Cottam Solar Project

Figure 8.16.7.2: Landscape and Ecology Mitigation and Enhancement Plan – Cottam 1 West Option B (Sheet 3)

Revision A

Document reference: EX1/C6.4.8.16.7.2_A

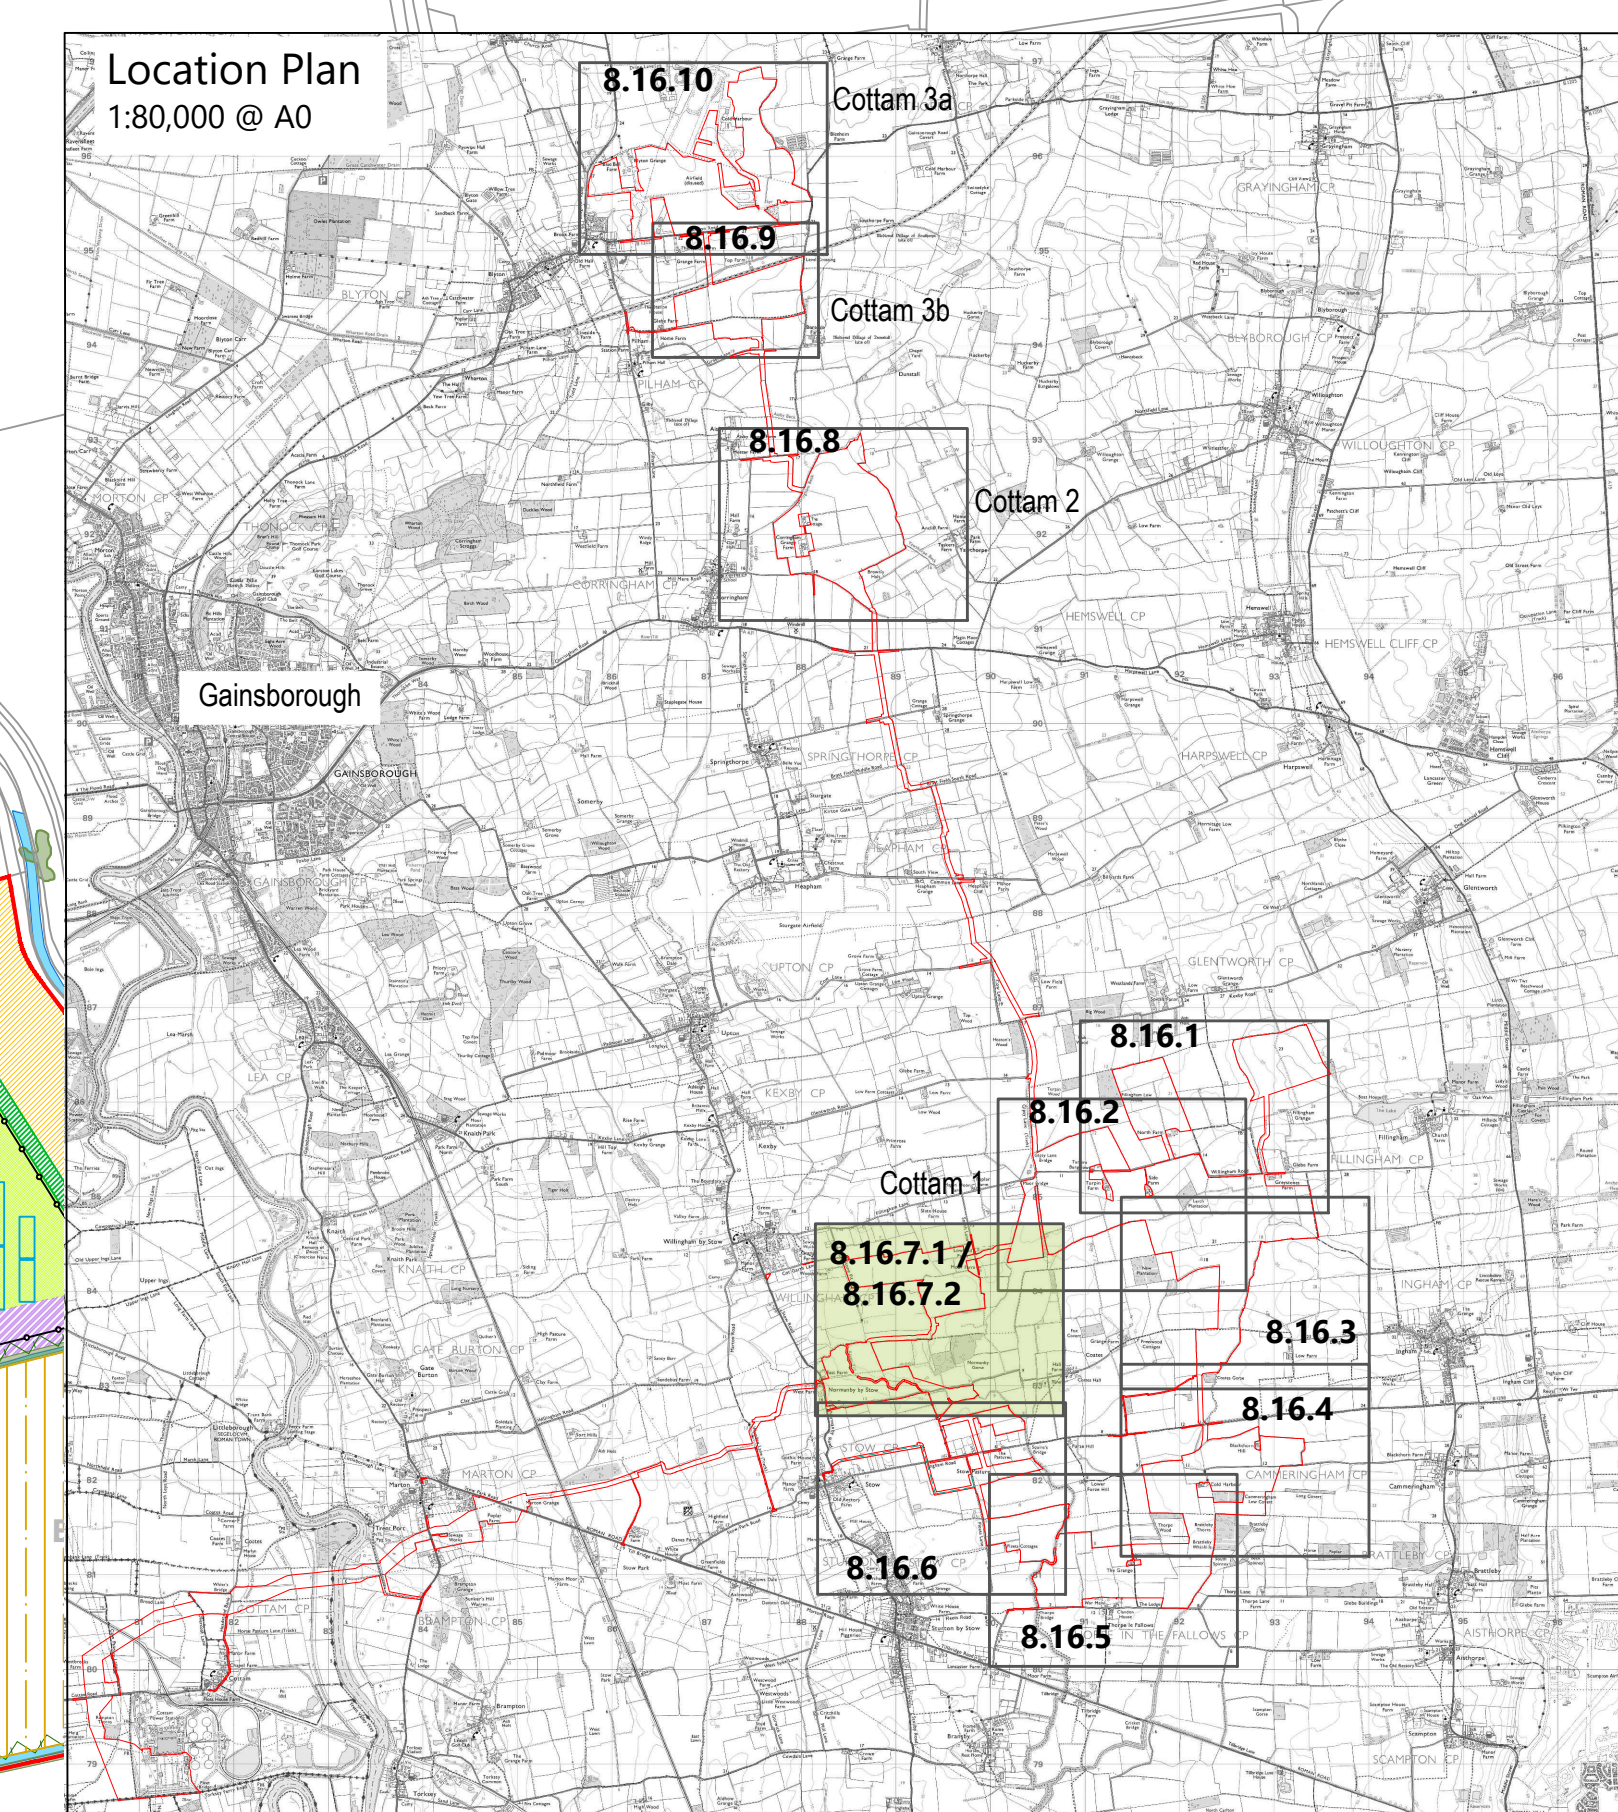
Figure Reference	Page	Description of Changes	Reason for Revision
Figure 8.16.7.2	3	Offset calculations from drains. Additional Hedgerows to be removed.	For clarity and consistency.
